Access Compliance Report

Public Rights-of-Way

| Intersection ID: 50616 | Main Street: PADDLE_OAK_RD | Cross Street: FAWN_LILY | Location: W |
| ADA ID: 3C368F332731 | Ramp Type: Perp | Initial Pass/Fail: Fail | Overall Compliance: No |

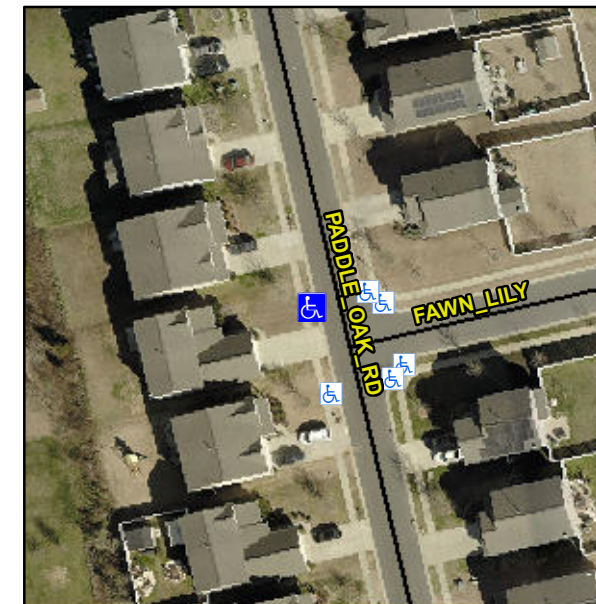
R304.5.1, R304.2.2, R304.5.3

| Compliance | Description | Data | Compliance | Description | Data |
|------------|-----------------------|------|------------|-----------------------------|------|
| N/A | Ramp Length (in) | 47.5 | No | Ramp Slope (%) | 10.8 |
| No | Ramp Width (in) | 47.0 | No | Ramp XSlope (%) | 3.2 |

Remove & Replace Entire Ramp.
